NAVIGATION - STALL WARNING HORN REPLACEMENT

The original stall warning horn is no longer available. If the stall warning horn needs to be replaced, a new stall warning horn is available and will require an additional bracket for installation.

MEB-34-07
Page 1 of 29

Figure 4. Group A Configuration 2 (Sheet 1)

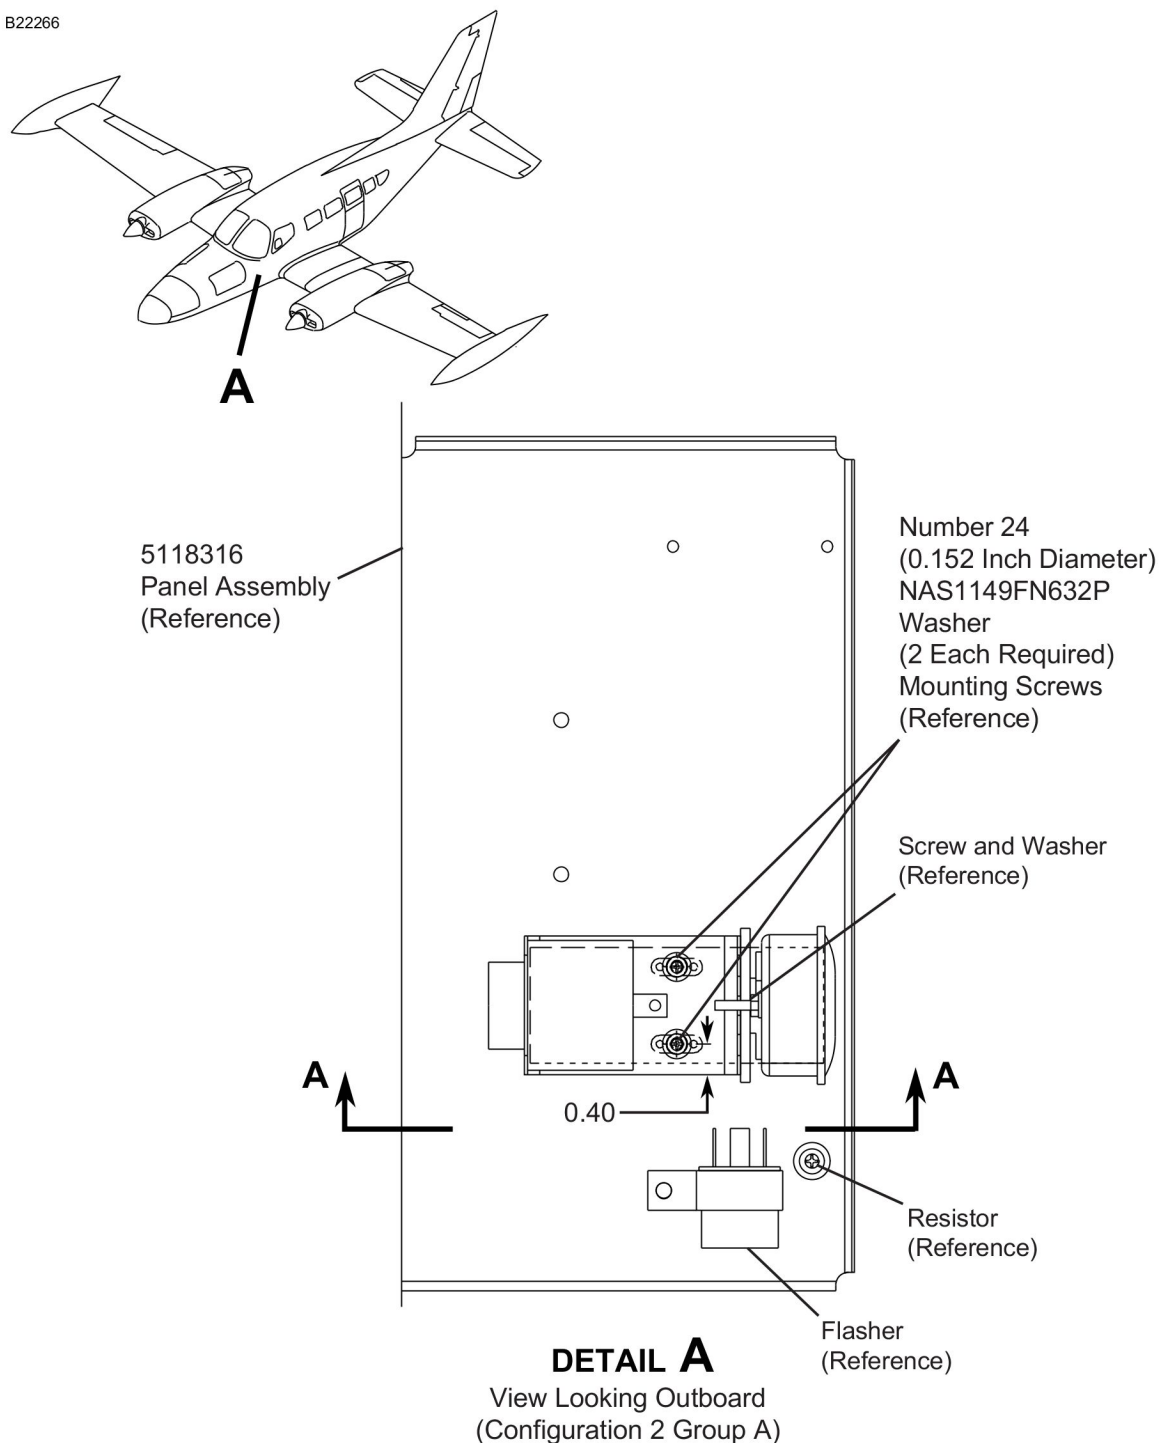
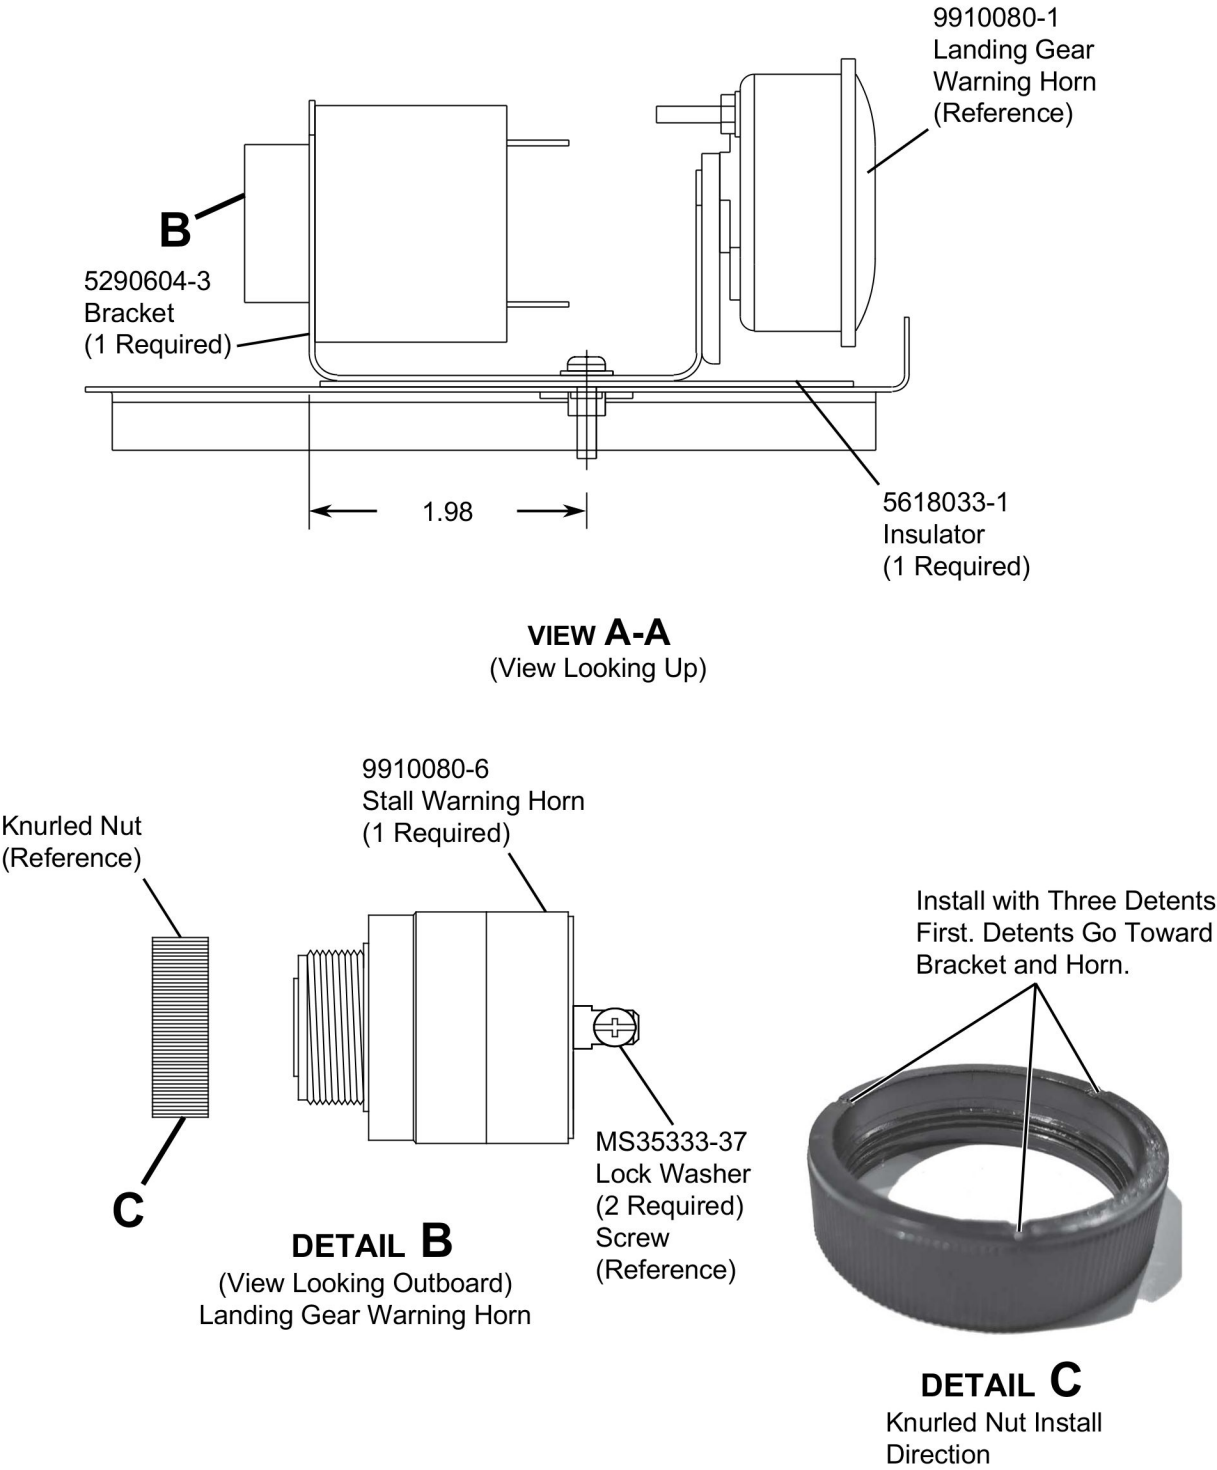
- 11. (Refer to Figure 4, Sheet 1 and 2.) Install the 9910080-6 Stall Warning Horn as follows:
 - A. Match drill the two Number 24 (0.152 inch diameter) holes of the 5118316 Panel Assembly into the 5290604-3 Bracket.

- (1) Deburr the drilled holes from the 5290604-3 Bracket.
 - (2) Apply Color Chemical Film Treatment to all bare metal.
 - B. Install the 5290604-3 Bracket and the 5618033-1 Insulator with the two kept mounting screws and the two NAS1149FN632P Washers into the 5118316 Panel Assembly.

- C. Install the 9910080-6 Stall Warning Horn into the 5290604-3 Bracket.
 - D. Install the knurled nut onto the 9910080-6 Stall Warning Horn.
NOTE: The plastic knurled nut must be installed with the three indents toward the bracket and horn assembly. On the internal circumference, the smooth side without threads is installed first, towards the bracket and horn. This technique of installation will make sure the nut fully seats against the bracket and not bottom-out on the threads. If not installed correctly the knurled nut will bottom-out on the threads and the horn assembly will not be fully tightened in the bracket.

- E. Install the labeled electrical wiring, screws, and the two MS35333-37 Lock Washers into the 9910080-6 Stall Warning Horn.
NOTE: The screws are supplied with the 9910080-6 Stall Warning Horn.

- 12. Install the 9910080-1 Landing Gear Warning Horn into the 5290604-3 Bracket with the kept screw and lock washer.
- 13. Do the 9910080-6 Stall Warning Horn operational check as follows:

Figure 5. Group B Configuration 2 (Sheet 1)

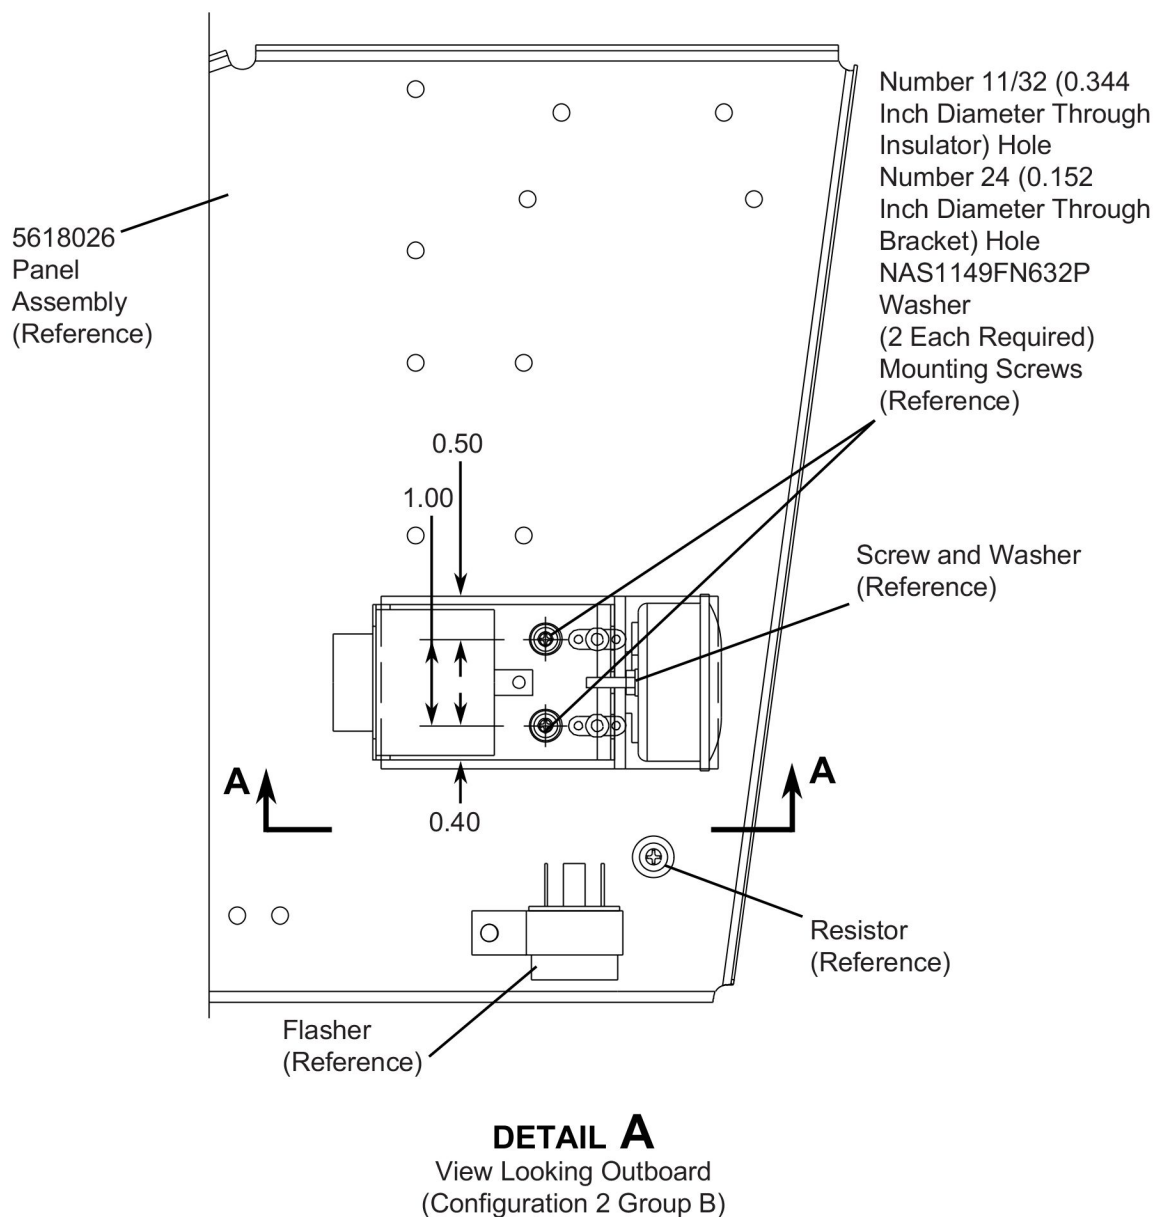
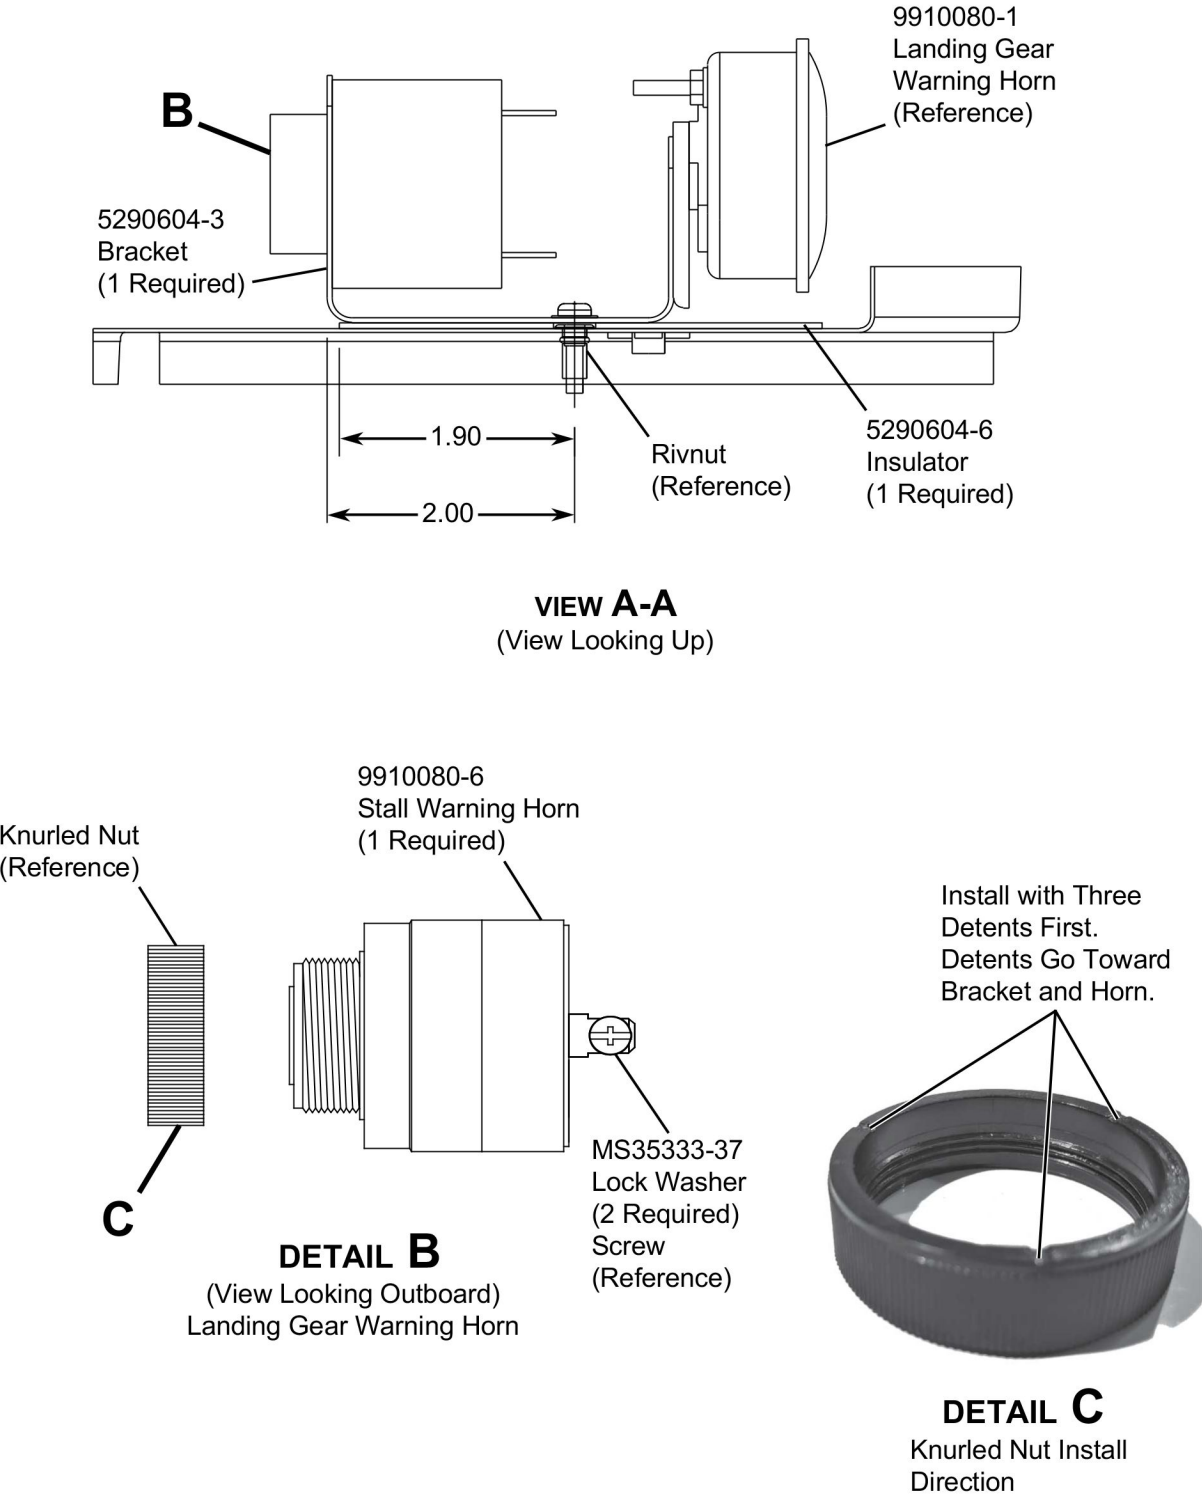
17. (Refer to Figure 5, Sheet 1 and 2.) Install the 9910080-6 Stall Warning Horn as follows:

A. Match drill the two new holes of the 5618026 Panel Assembly to a Number 11/32 (0.344 inch diameter) holes into the 5290604-6 Insulator.

B. Match drill the two new holes of the 5618026 Panel Assembly to a Number 24 (0.152 inch diameter) holes into the 5290604-3 Bracket.

C. Install the 5290604-3 Bracket and the 5290604-6 Insulator into the rivnuts of the 5618026 Panel Assembly with the two kept mounting screws and the two NAS1149FN632P Washers.

D. Install the 9910080-6 Stall Warning Horn into the 5290604-3 Bracket.

18. Install the 9910080-1 Landing Gear Warning Horn into the 5290604-3 Bracket with the kept screw and lock washer.

Figure 6. Group A Before Configuration 3 Modification (Sheet 1)

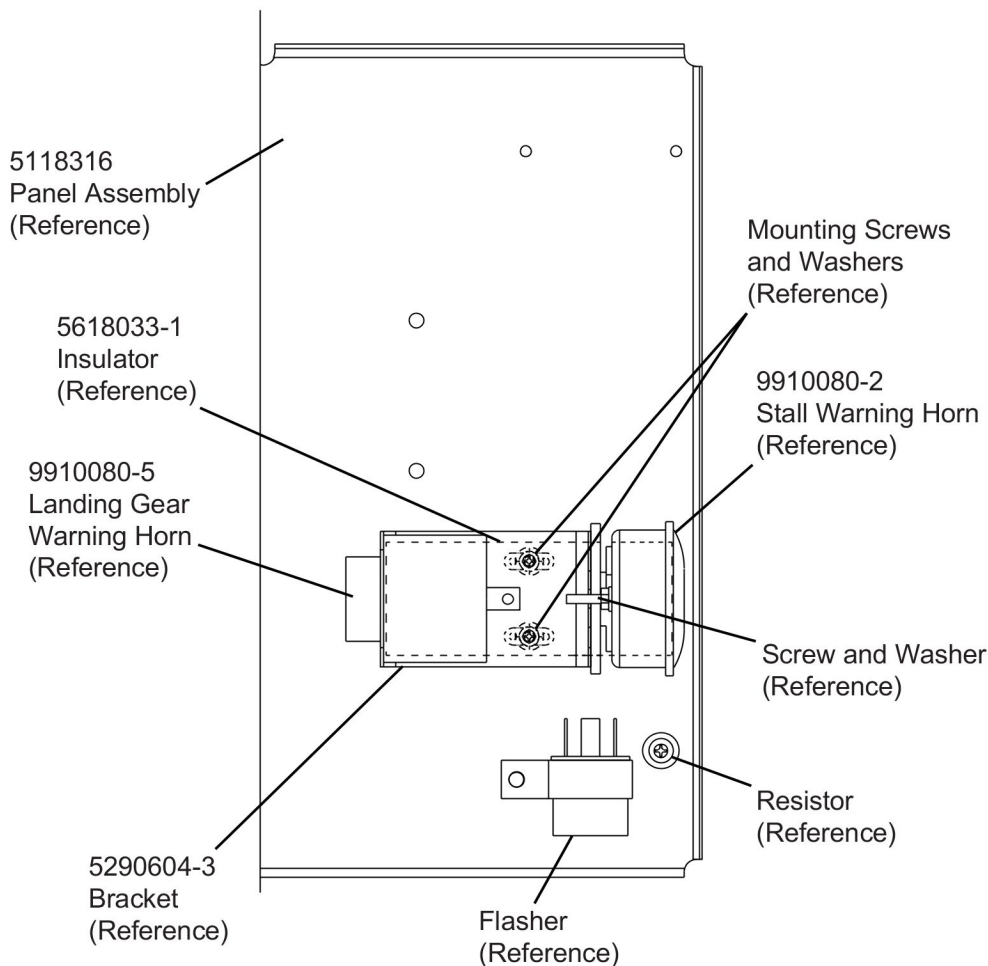
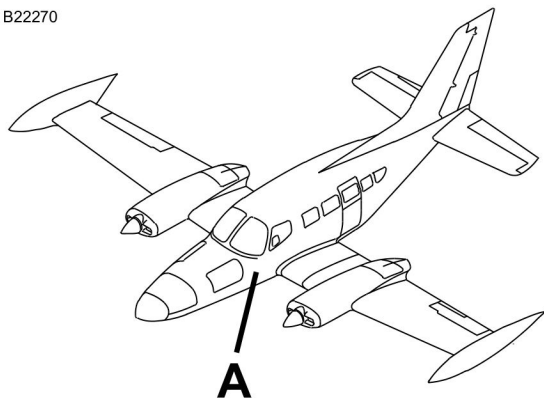
- 22. (Refer to Figure 6, Sheet 1.) Remove the 5290604-3 Bracket as follows:
 - A. Remove and discard the screw and lock washer from the 9910080-2 Stall Warning Horn.
 - B. Disconnect and label the electrical wiring from the 9910080-2 Stall Warning Horn.
 - C. Discard all electrical hardware from the 9910080-2 Stall Warning Horn.
 - D. Discard the 9910080-2 Stall Warning Horn.
 - E. Remove and keep the 9910080-5 Landing Gear Warning Horn.

NOTE: The kept 9910080-5 Landing Gear Warning Horn will be used during installation.
 - F. Remove and keep the two mounting screws and the two washers from the 5290604-3 Bracket.

NOTE: The kept mounting screws and washers will be used during installation.
 - G. Discard the 5618033-1 Insulator and the 5290604-3 Bracket.
